**CONSTRUCTION ADDENDUM: 1**

**PROJECT NAME:** RAD Briarwood Electrical Repairs**PROJECT MANAGER:** Carl Frankel**PHONE NUMBER:** 425.891.3317**EMAIL ADDRESS:** carlf@kcha.org

# BW Typical Unit Layout

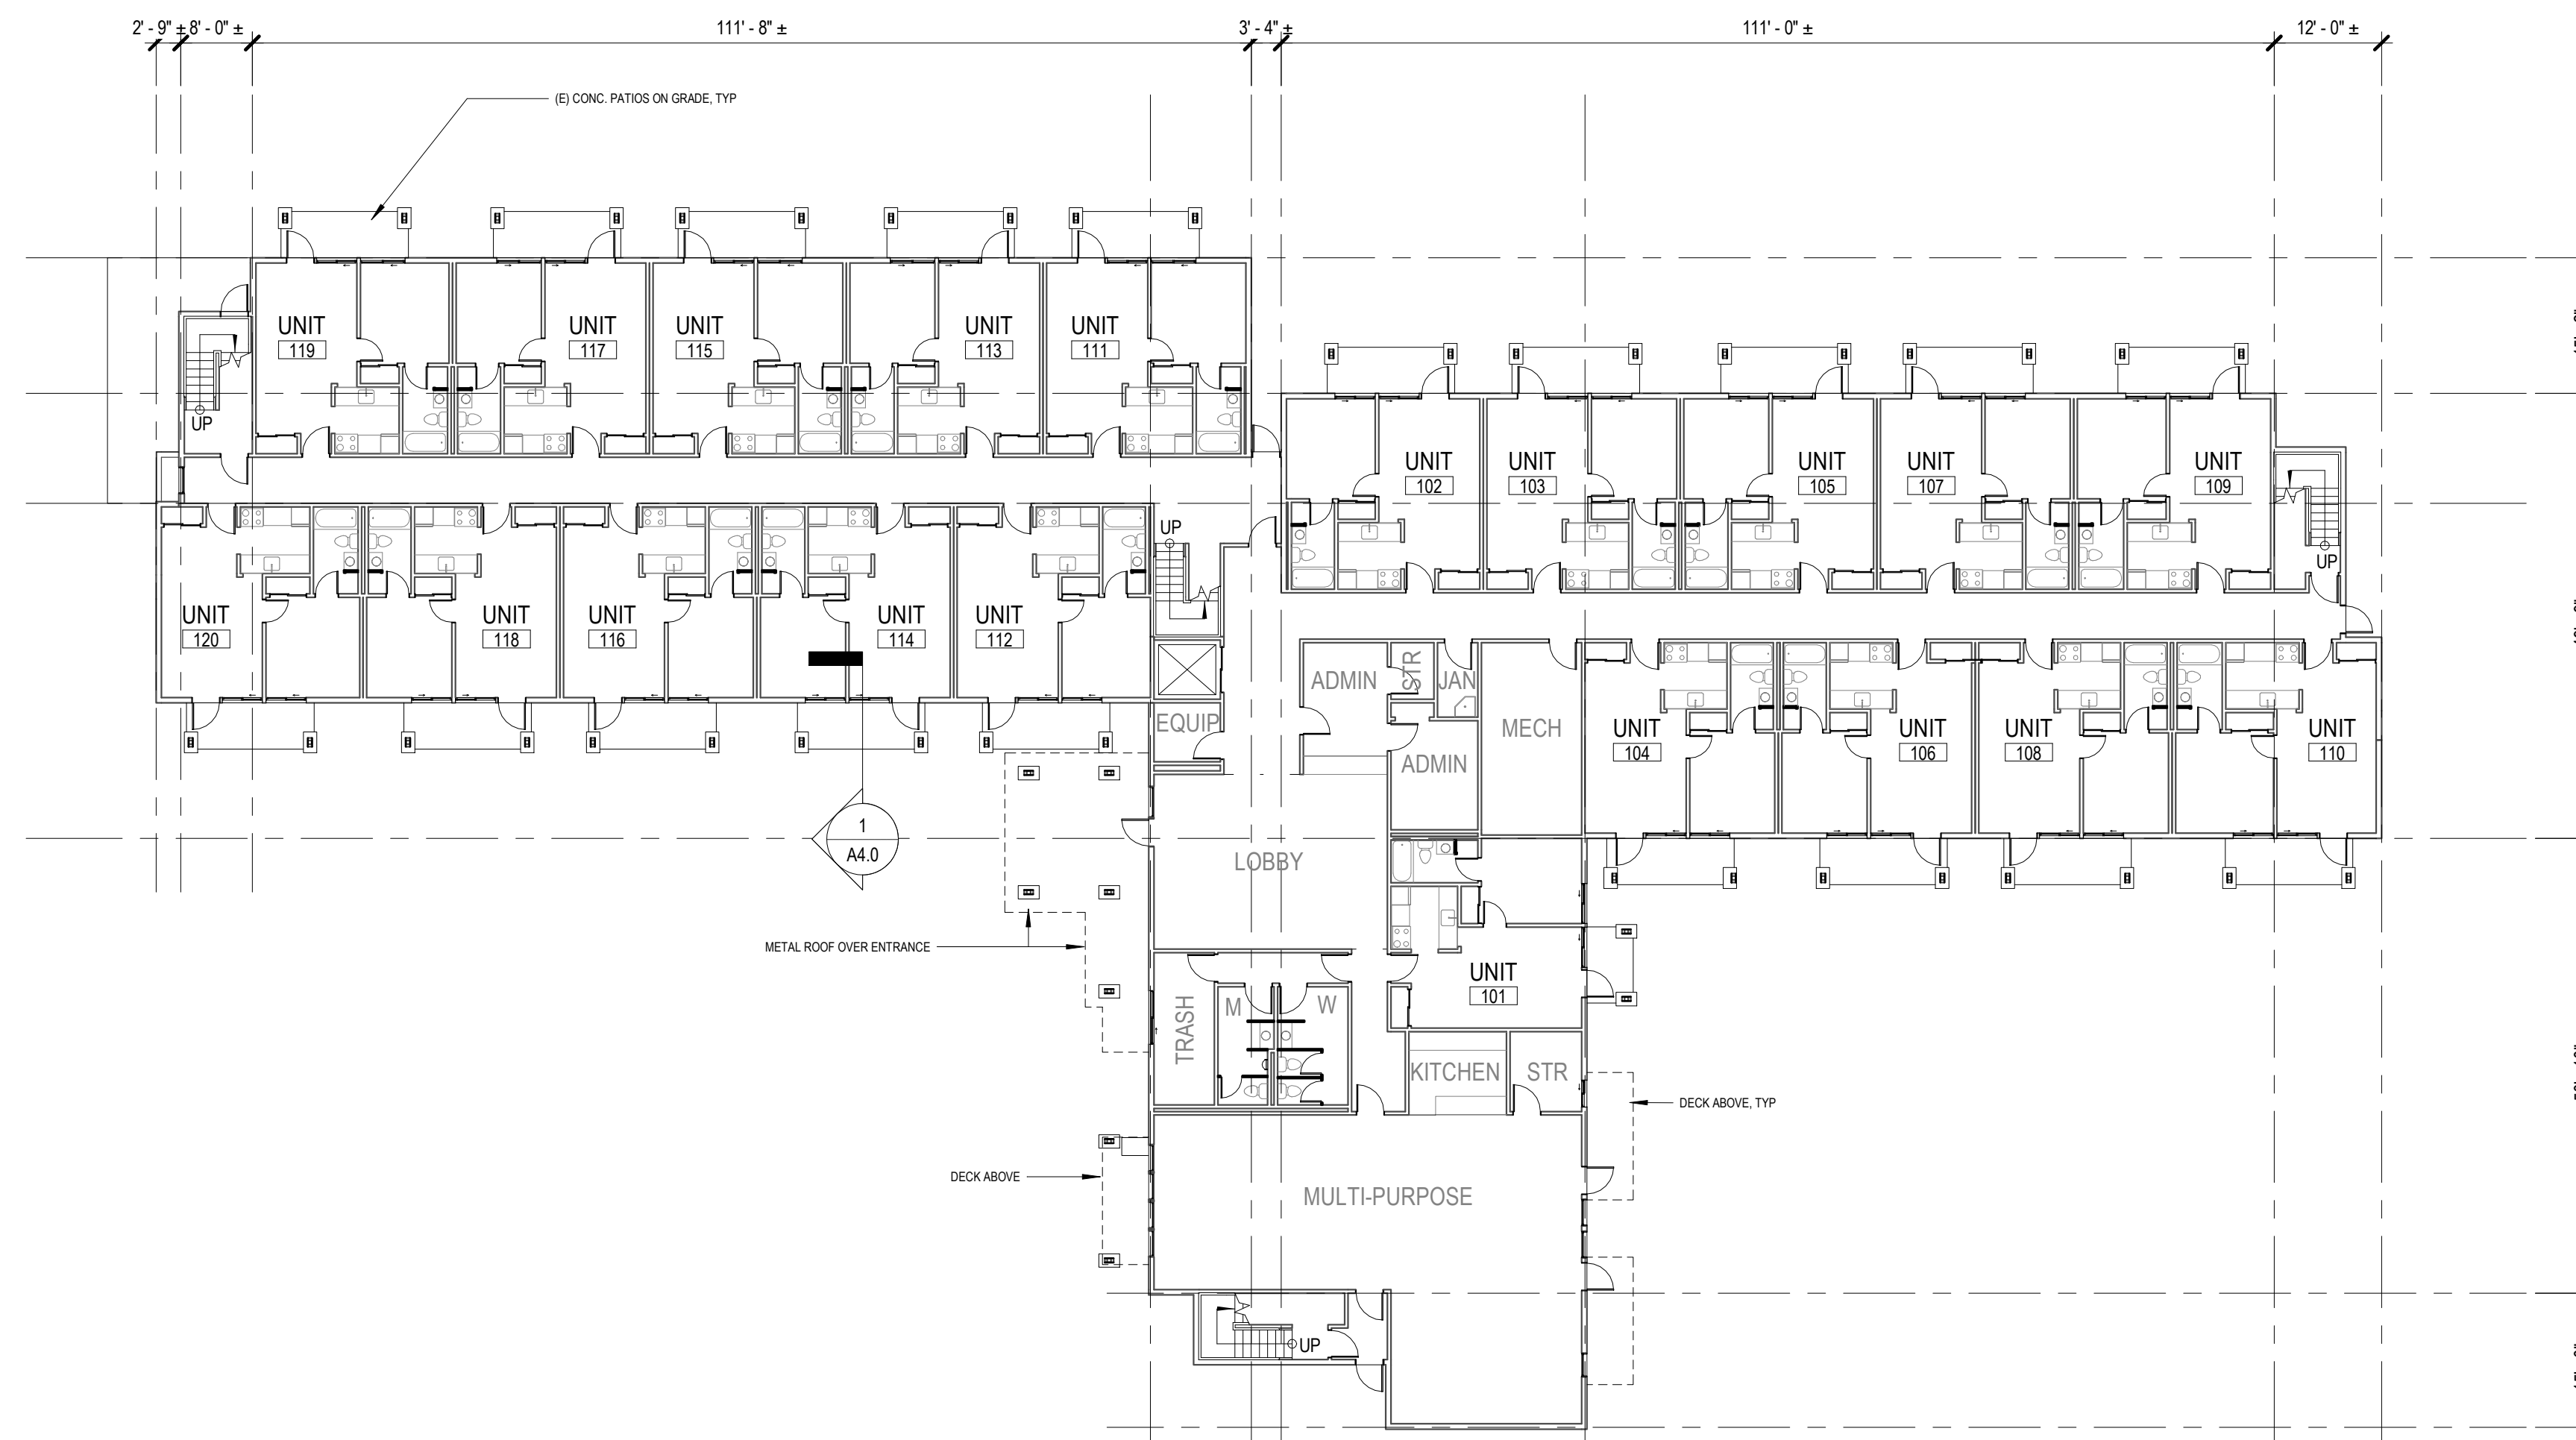
- 13: ADD: A diagram of typical units is included for reference. (BW Unit Layout 1) Do not scale.
- 14: ADD: Each unit has one (1) mini split heat pump and one (1) electric heater.
